PLANT NAMES: Diablo Canyon Units 1 & 2

APPLICANT'S Responses to Comments submitted by the Department of the Interior & the State of California on the Draft Enviro Statement notarized 5-7-73 & (2) Drawings as supplementary info in connection with our responses to Environmental Protection Agency comments

Re: Dockets 50-275, 50-323  
Diablo Canyon Site  
Units 1 and 2

Pacific Gas and Electric Company hereby submits its responses to comments submitted by the Department of the Interior and the State of California on the Draft Environmental Statement for Units 1 and 2 at the Diablo Canyon Site. The comments covered in this response are those forwarded by the AEC with letters of transmittal dated April 4, and April 19, 1973.

# DIABLO CANYON INTAKE SURVEY

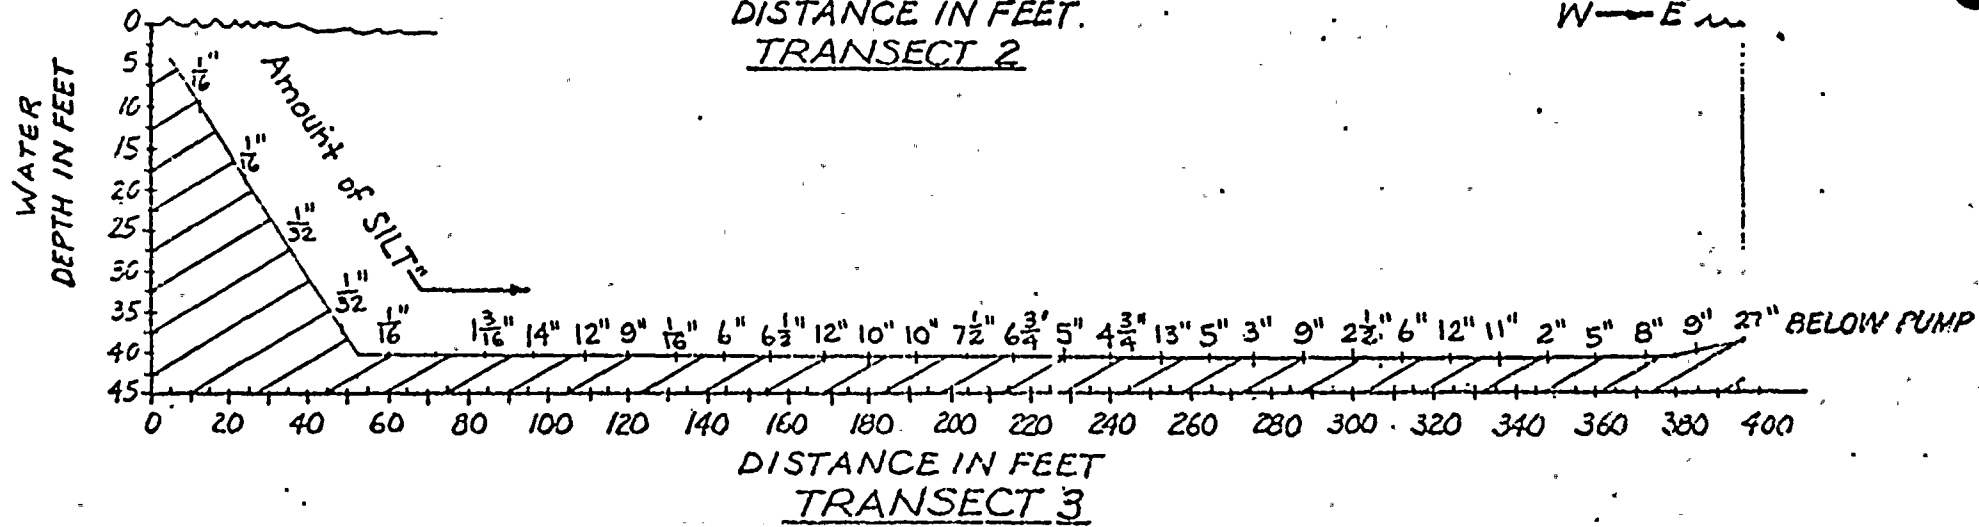
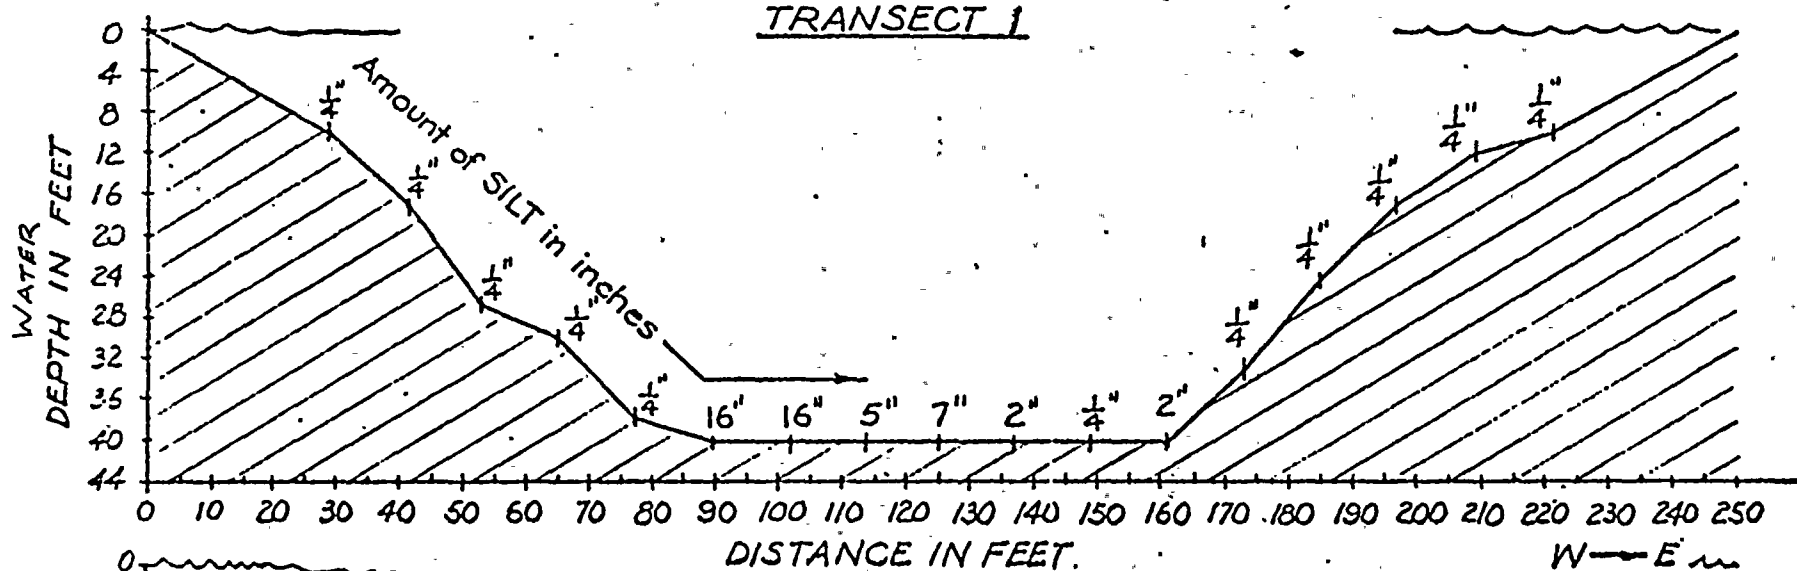
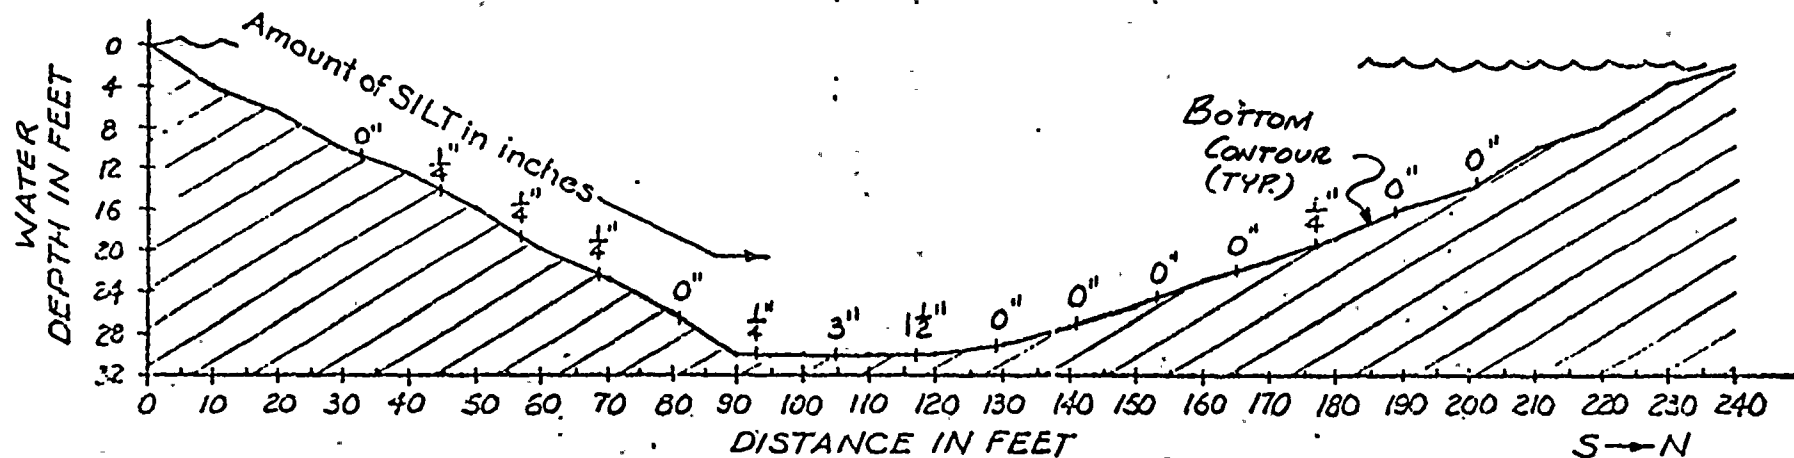
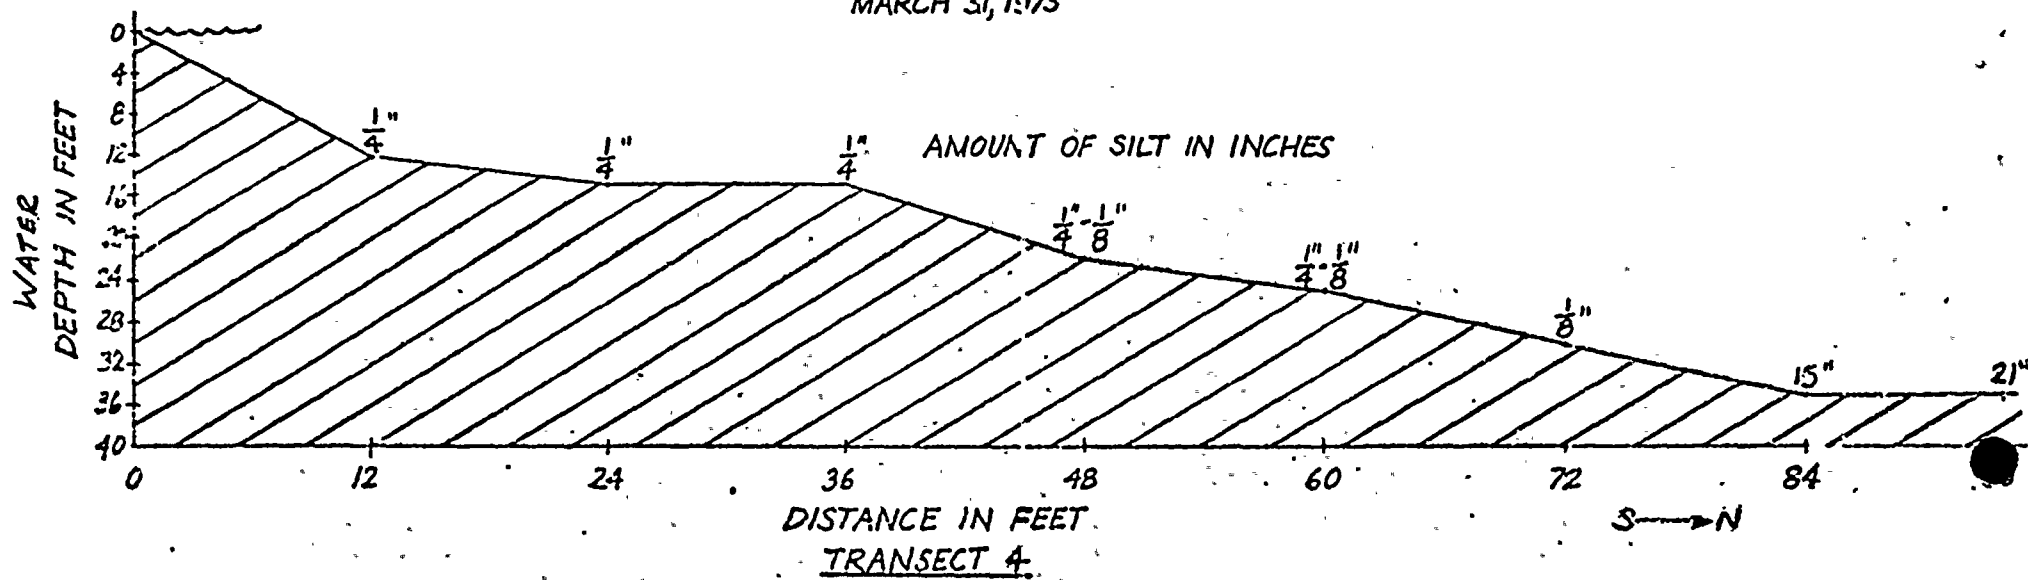
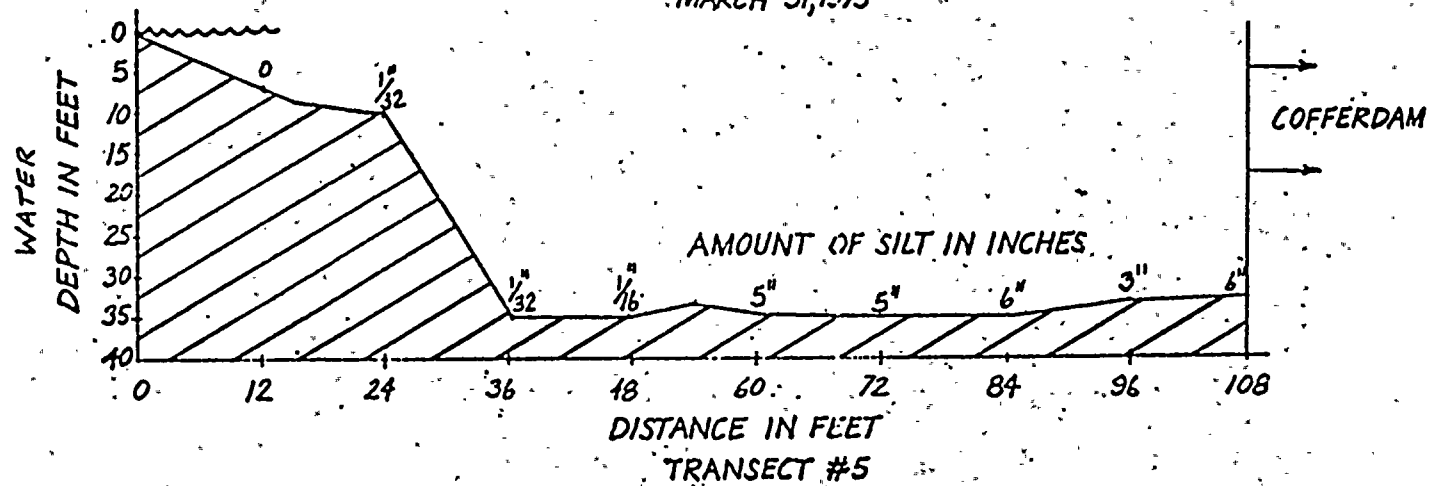
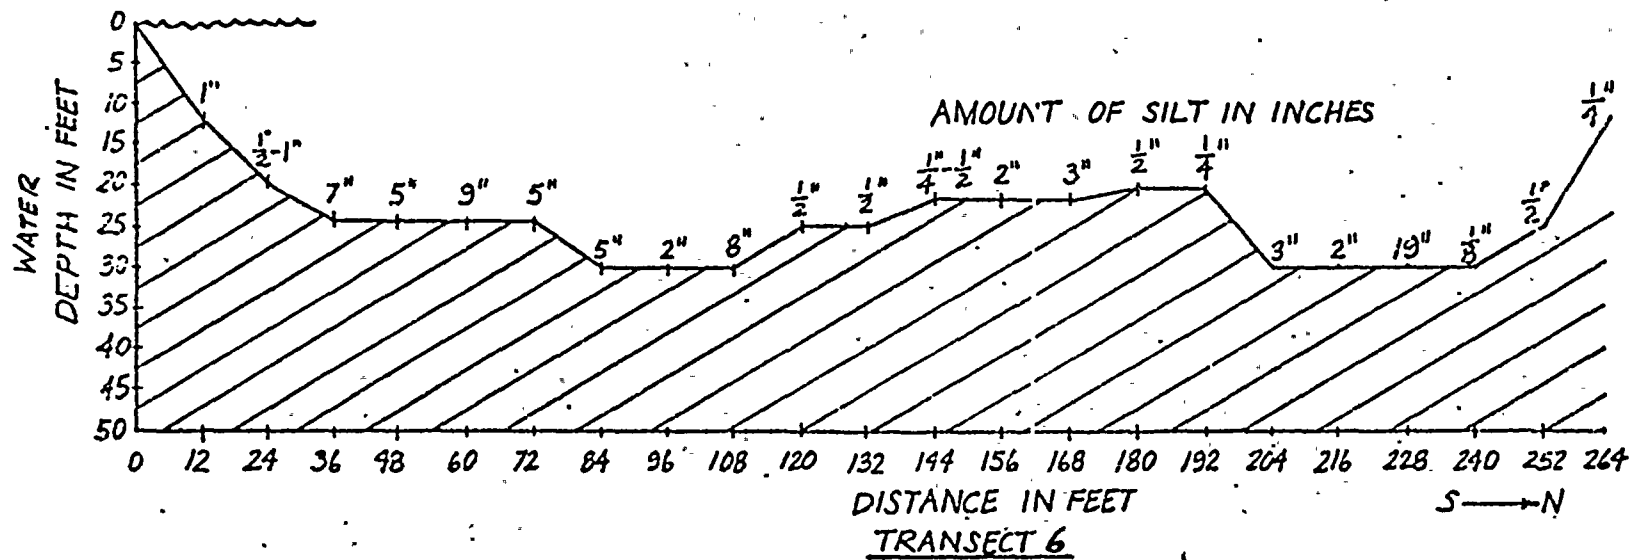
- b) Comments: "The deposition of silt in South Cove as a result of intake construction activities and the biotic degradation of the cove should be described and quantified to the extent possible."

The effects of silt deposition on benthic biology are discussed on Pages IV-E-27 to IV-E-29 of Supplement No. 2 to PG&E's Environmental Report. Depths of silt observed during reconnaissance surveys in March and April of 1972 are also described. During subsequent construction, some additional silting has occurred. The attached drawings show silt depths recorded during a survey on March 31, 1973.

Intake construction is now almost complete, and cofferdam removal is scheduled to take place soon. This action is not expected to create any significant changes in the silt depths that are shown on the attached drawings.

# INTAKE BASIN BREAKWATERS FOR DIABLO CANYON SITE PACIFIC GAS & ELECTRIC COMPANY

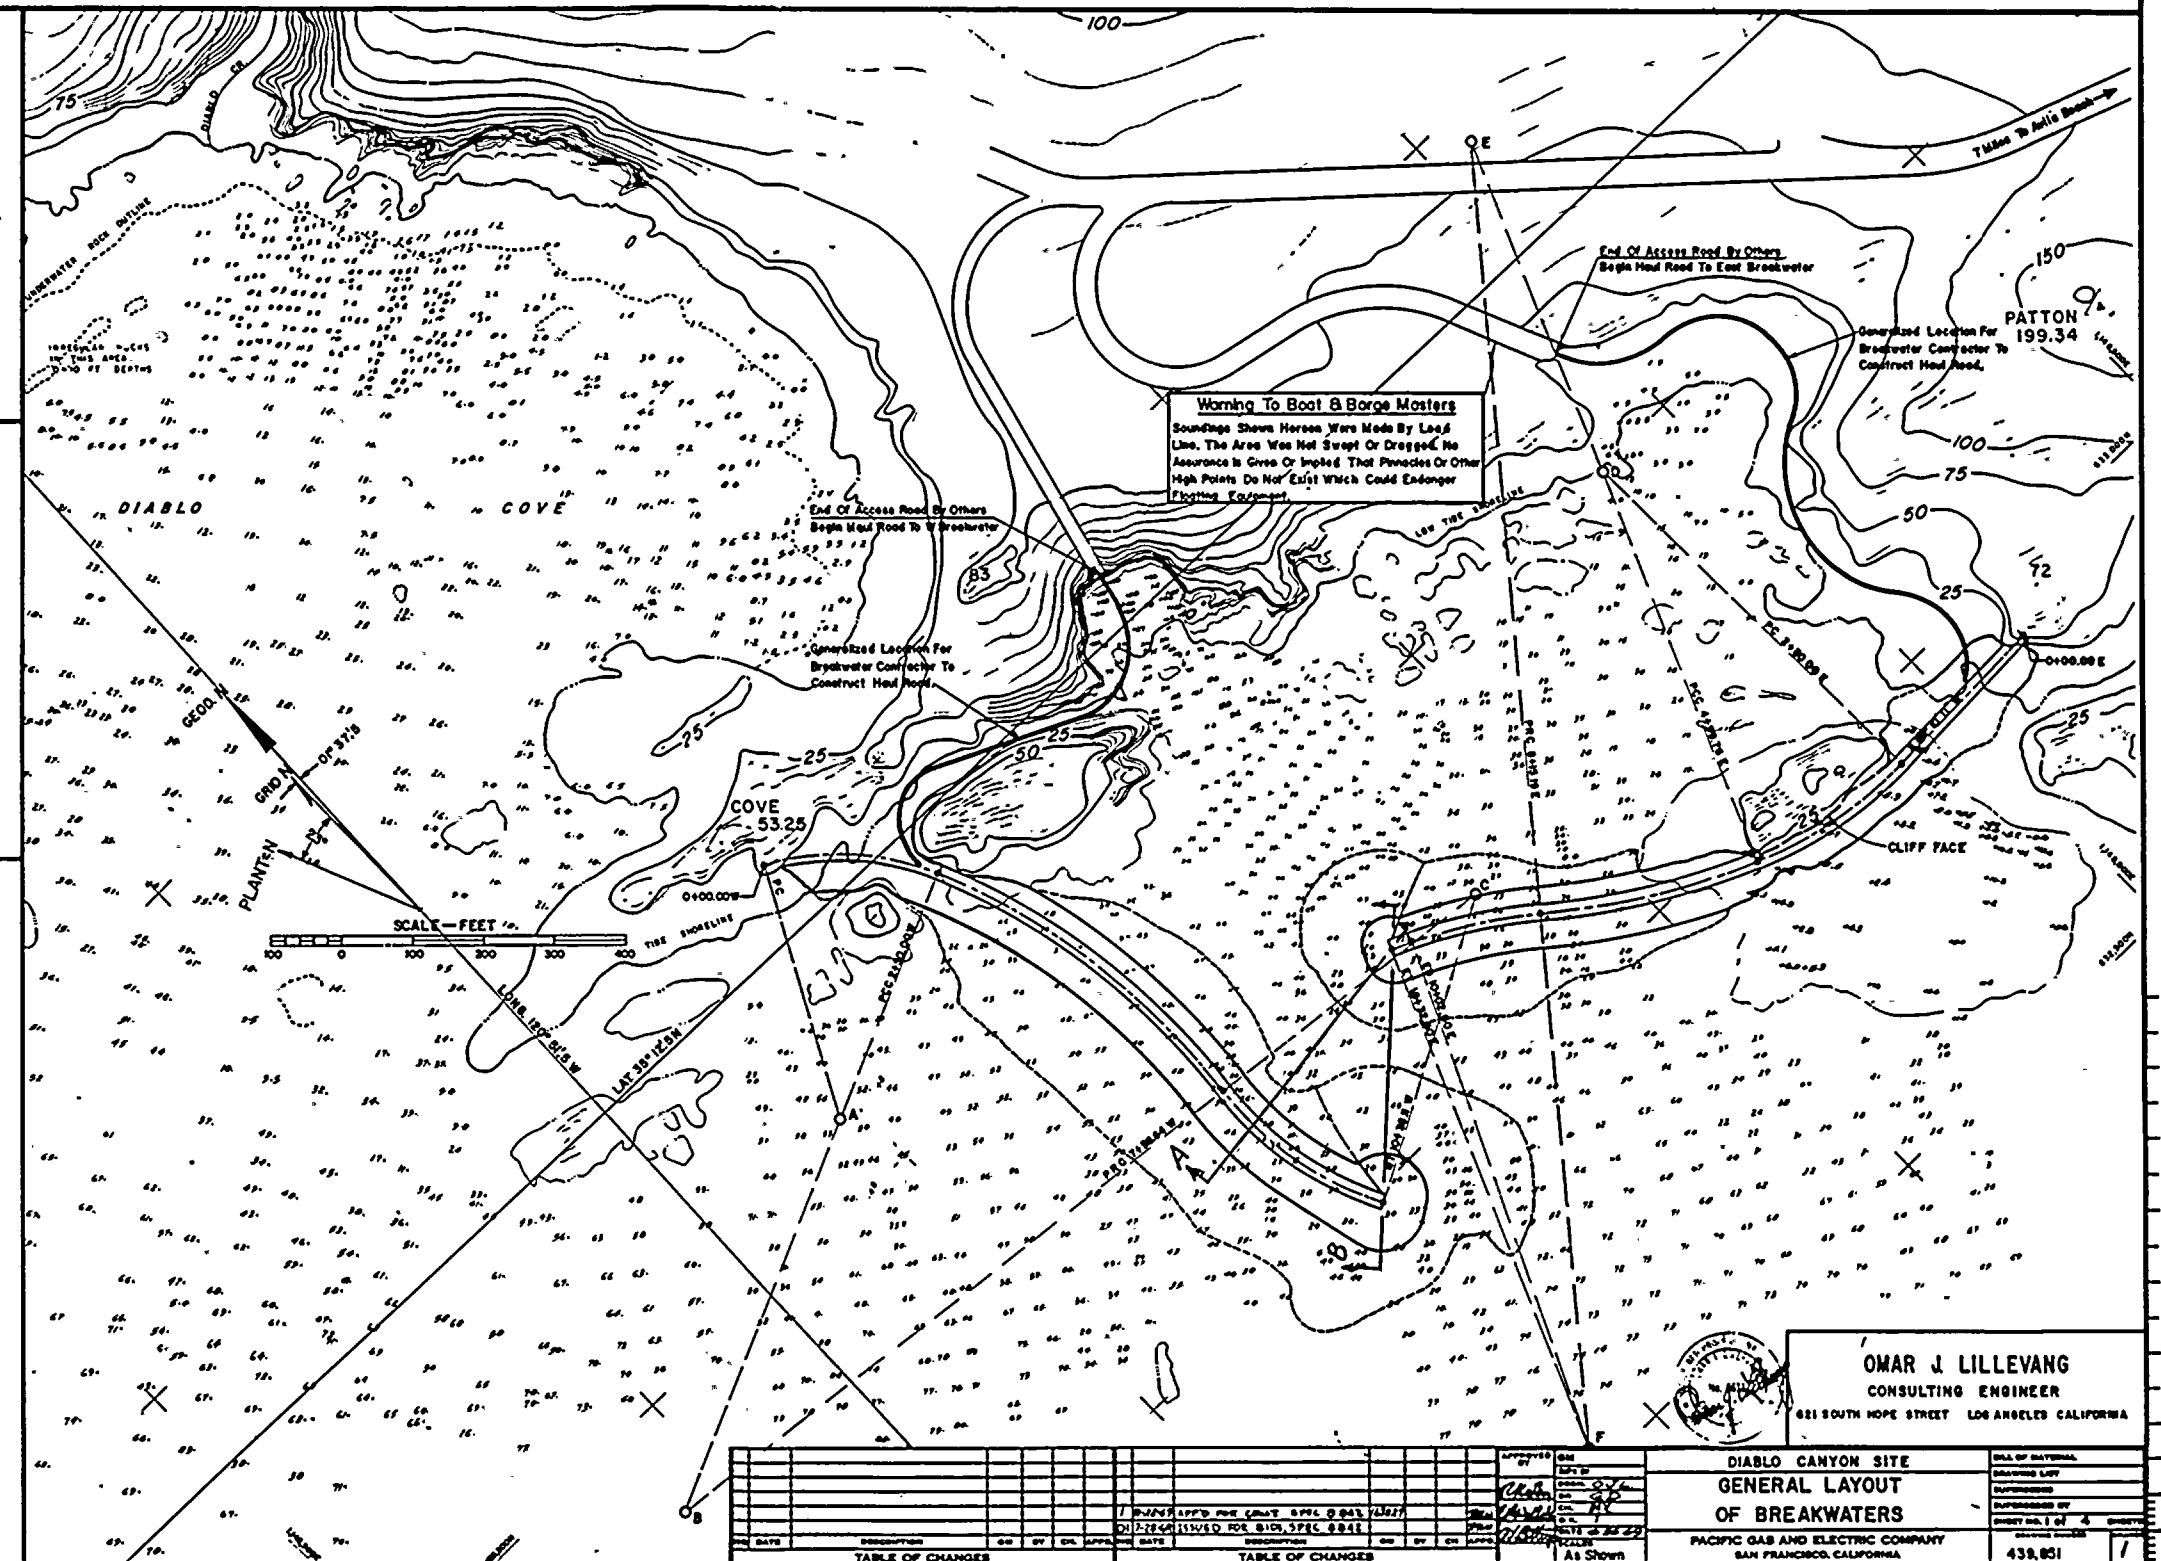
These drawings are submitted as supplementary information in connection with PGandE's responses to Environmental Protection Agency comments on the AEC Draft Environmental Statement. Responses to these comments were included with the submittal to the Commission dated March 21, 1973. These drawings relate to the Environmental Protection Agency comments concerning

the velocity of water entering the intake cove (page 12, paragraph 2 of EPA comments dated February, 1973).
